**NOTICE OF A REGULAR MEETING
BONDURANT PLANNING AND ZONING COMMISSION
MARCH 28, 2019**

PLANNING AND ZONING COMMISSION
RESOLUTION NO. PZ-190314-07

Prepared by: Marketa Oliver, City Administrator, incorporating
information from Beth Richmond at HGKI
March 25, 2019

BONDURANT, IOWA
BONDURANT COMMERCIAL - LOT 7
SITE PLAN REVIEW

LANDSCAPE NOTES

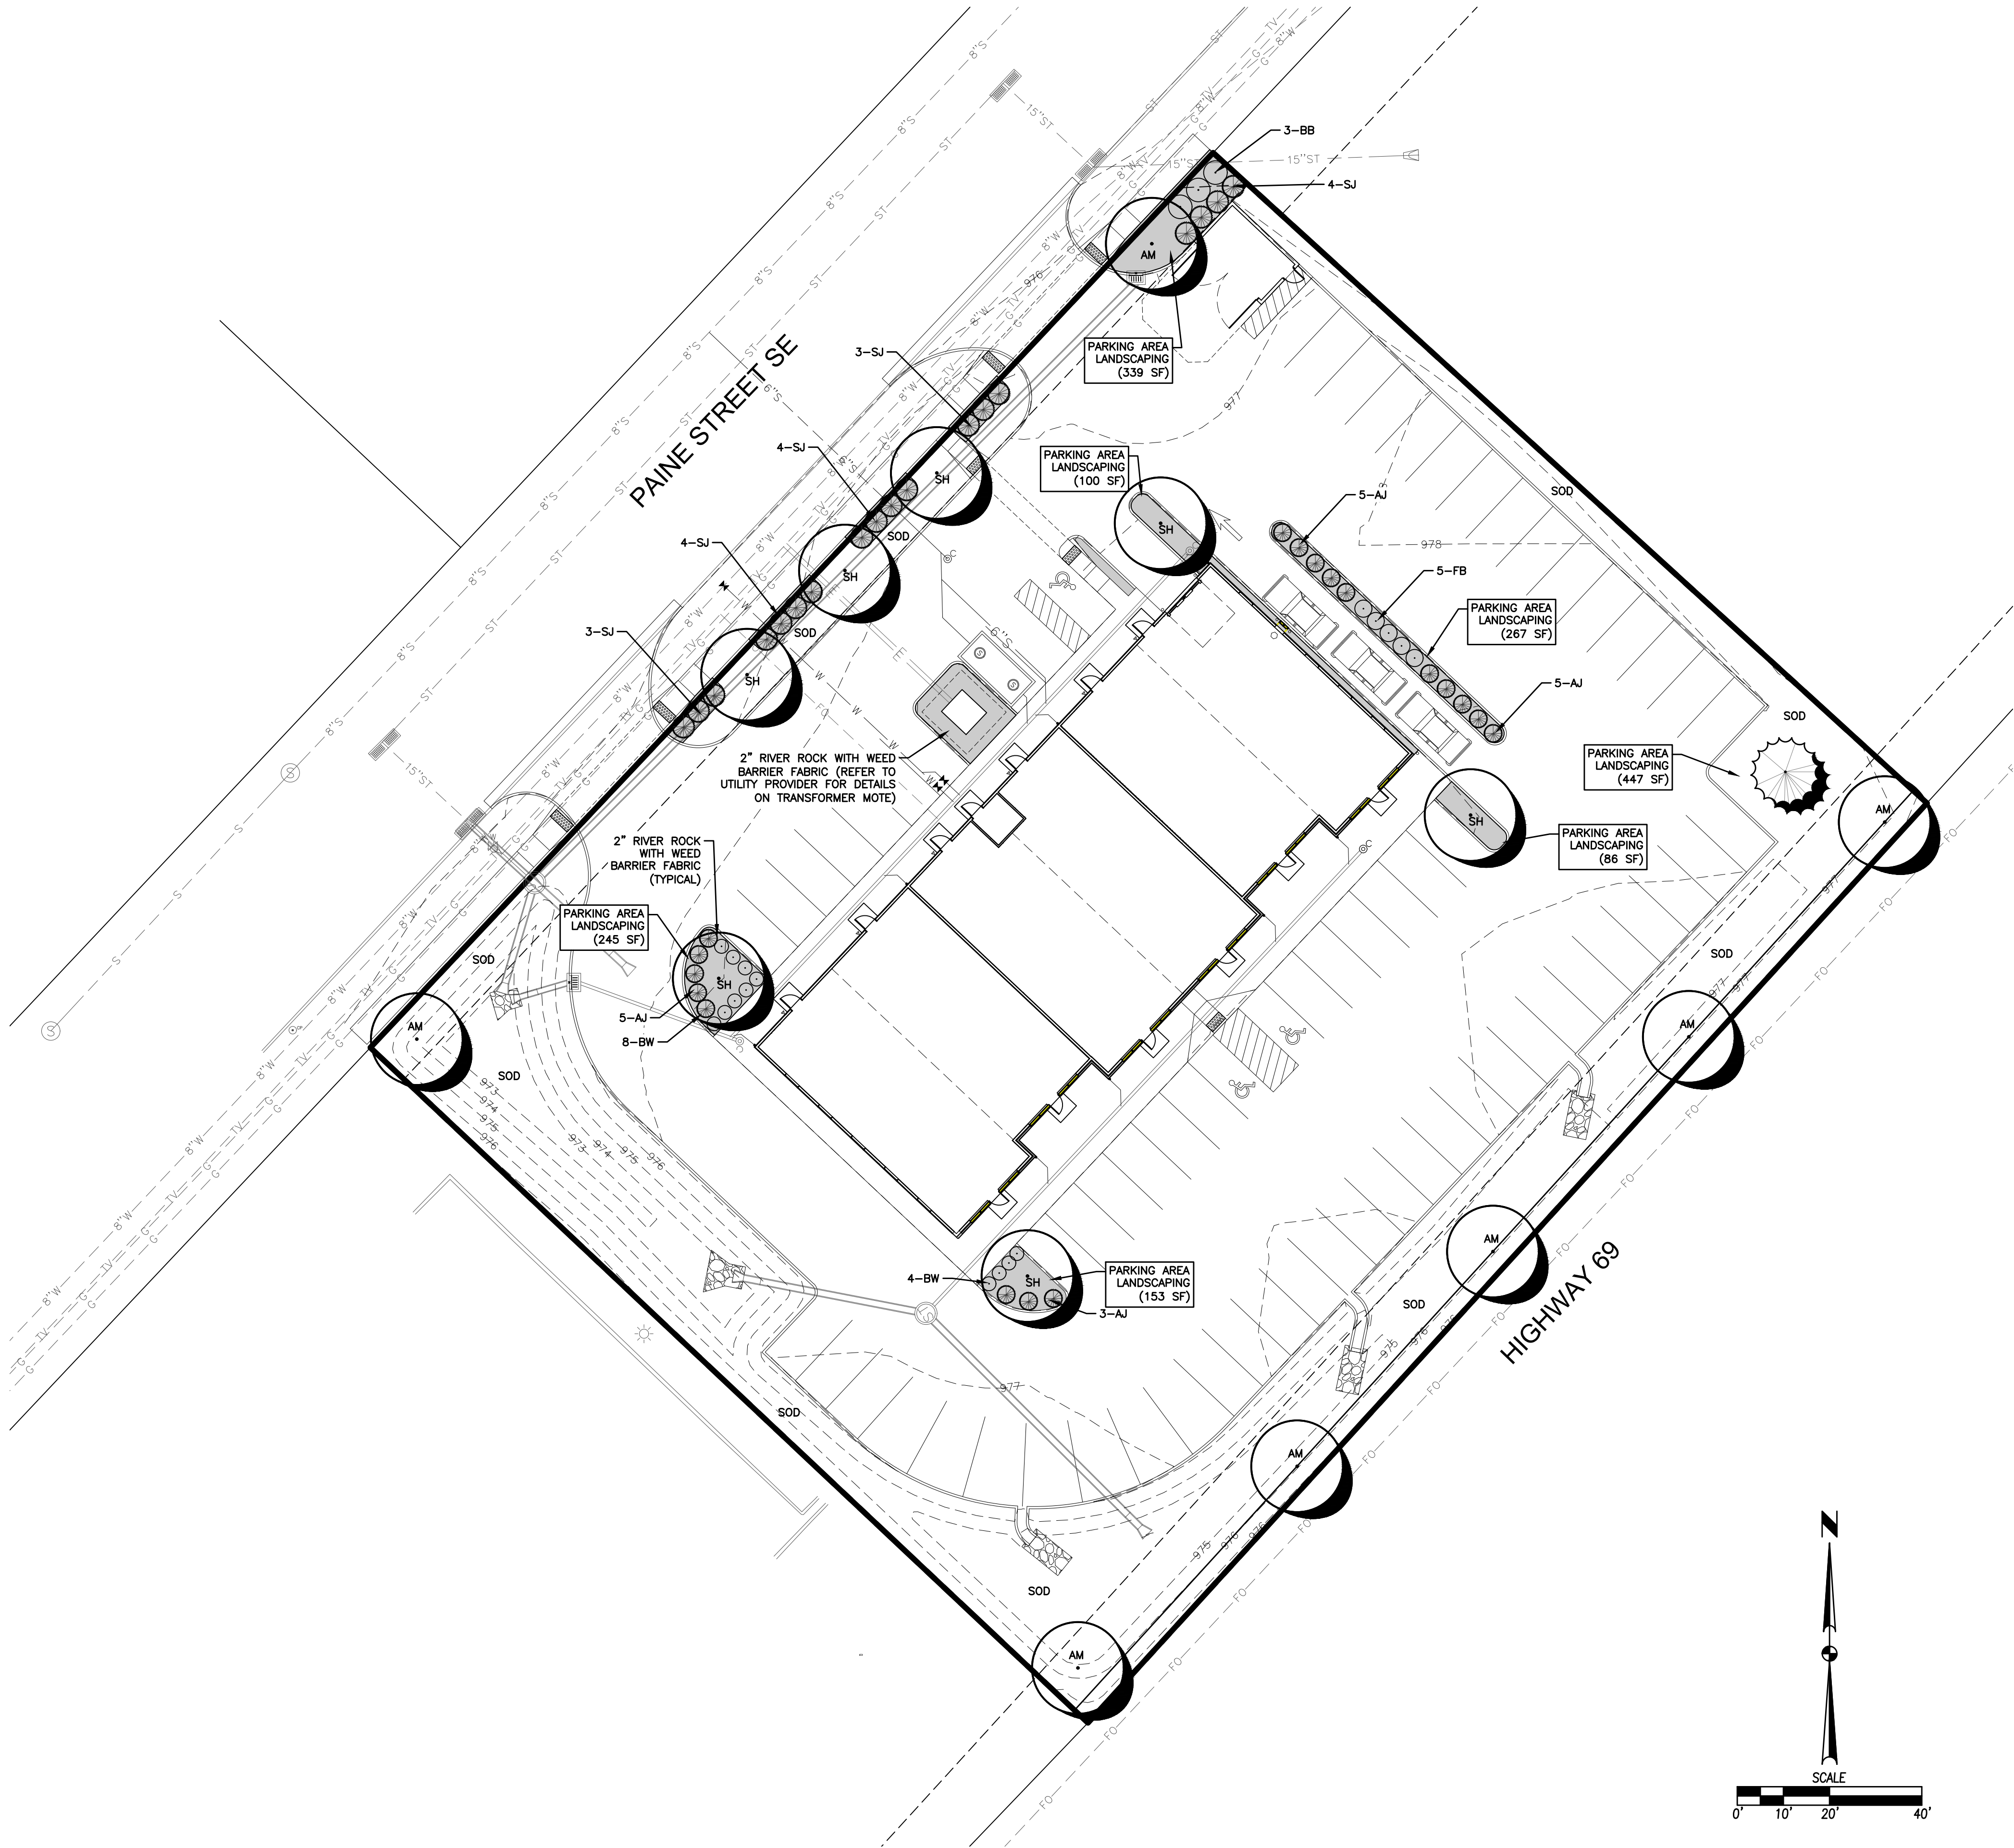
The applicant has provided a landscaping plan. There are several requirements for landscaping that the applicant must meet on this site, including total trees, number of front yard trees, and interior parking lot trees.

The total number of trees on the lot is required to be either one tree per 50 feet of frontage or one tree per six parking spaces provided, whichever is greater. In this case, the applicant is proposing to create 68 parking spaces on site, requiring a minimum of 11 trees. The site's frontage is roughly 270 feet, requiring 5 trees. Therefore, 11 trees will be required overall on the site. In total, the applicant is proposing to plant 15 trees and 35 shrubs on the site. This meets the total tree requirement specified by Code.

One tree per 50 feet of frontage is required to be planted in the front yard setback, meaning 5 trees must be planted in the setback along Paine Street SE. 5 trees are included in the site plan, meeting this requirement.

Section 182.05.4.B requires one tree for every 18 parking spaces to be planted within the parking lot itself. Within the parking lot, tree islands must have an area of at least 36 square feet and a width of 5 feet. The proposed site plan shows a parking lot of 68 spaces. Therefore, 4 interior parking lot trees are required. The applicant provides a total of 4 interior parking lot trees.

13. The site plan includes the landscaping plan. The landscaping plan indicates the governing criteria for trees is the 68 parking stalls. The parking stall based requirement is for 12 trees. A total of 12 trees are being provided.

14. The site plan indicates there are a total of 43 shrubs located adjacent to the building, including the traffic island on the northeast side of the drive-thru lane. The City's site plan ordinance would not require a placement of shrubs above and beyond the placement of the mandated trees.

5. The applicant shall be required to landscape at least 5 percent of the parking area, or about 1,565 square feet.
6. The applicant shall plant at least 5 trees within the front yard setback but no closer than 4 feet to the public right-of-way.

7. The applicant must provide at least 4 deciduous interior parking lot trees placed within parking lot islands. These islands shall be at least 5 feet wide and have an area of at least 36 square feet.

EXTERIOR
ELEVATIONS

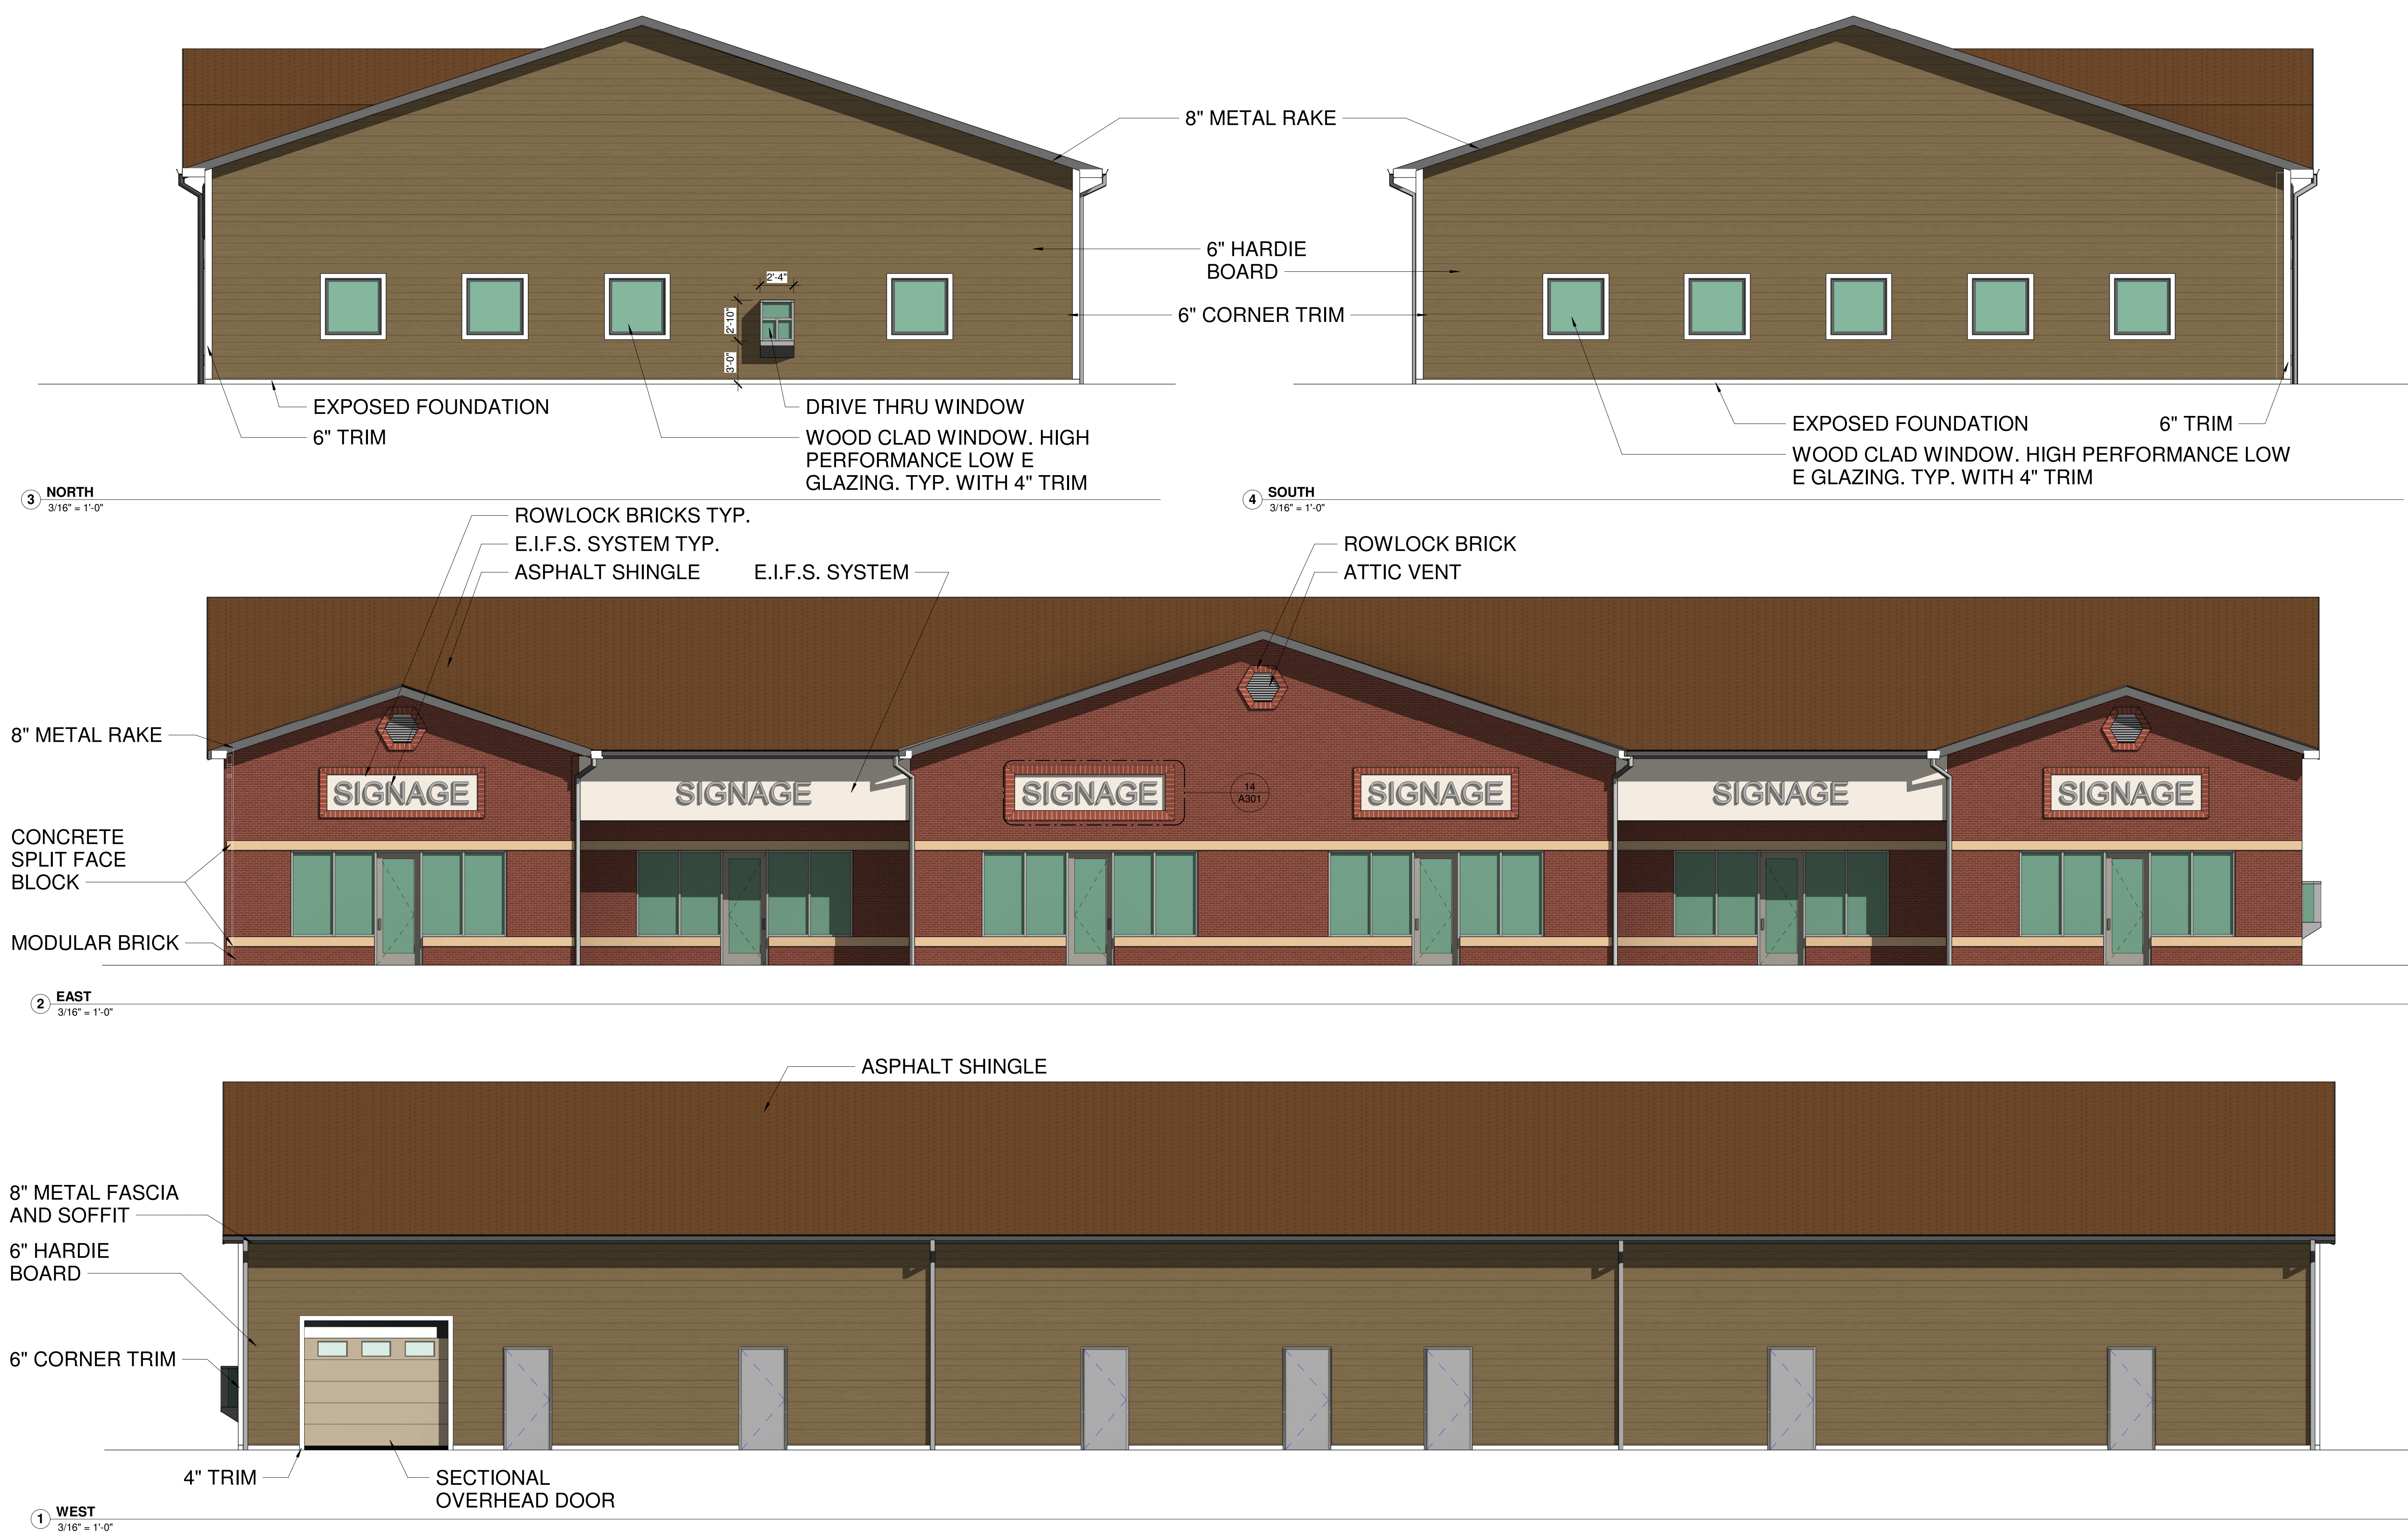
During a site plan review, the City reviews the architectural details of the plan to ensure that the proposed buildings fit with the character and overall vision for the community. The proposed building has a front façade facing Highway 65 and a rear façade facing Paine Street SE.

Because this site is located adjacent to Highway 65, it is part of the architectural Arterial Corridor Overlay. This overlay requires all buildings to include brick, stone, or glass on 100% of any façade facing Highway 65 or another public street. The applicant is proposing to construct the front facade using mainly brick and glass, with split face block as a secondary material. This façade meets the requirements of the arterial corridor overlay. The rear façade facing Paine Street SE is proposed to be built of Hardie board, or cement board siding. The rear of the building would be consistent with other buildings in the area and would be enhanced from street view with additional landscaping.

The side facades are proposed to be built of Hardie board, similar to the rear façade. The Code specifies that the side, or non-public, façades should complement the front and rear of the building in terms of architectural design elements, materials, and colors. The required building materials of brick, stone, and/or glass must be present at least as trim material on the side facades. As you can see in the colored elevations provided by the developer, there are windows proposed in the sides.

Buildings in this overlay should be designed to minimize single plane walls and a boxy appearance and must incorporate façade modulation in all building elevations visible to the public in order to reduce the effect of long, large, or expansive wall surfaces. The front façade meets this requirement by providing building offsets that break up the flat expanse of wall. The articulation in the rear of the building facing Paine Street SE will be accomplished with additional landscaping, as opposed to requiring a second façade on the building rear. Because the access points to this site are located off of Paine Street SE, it is important to provide screening.

Reflecting the findings in the architecture section above, all sides of a building should express consistent architectural detail with primary use of durable materials. The applicant is proposing to use Hardie board as the primary material for the drive-through side of the building. This material is a complementary color to the materials used for the front façade of the building and there is glass on the side of the building, as on the front.
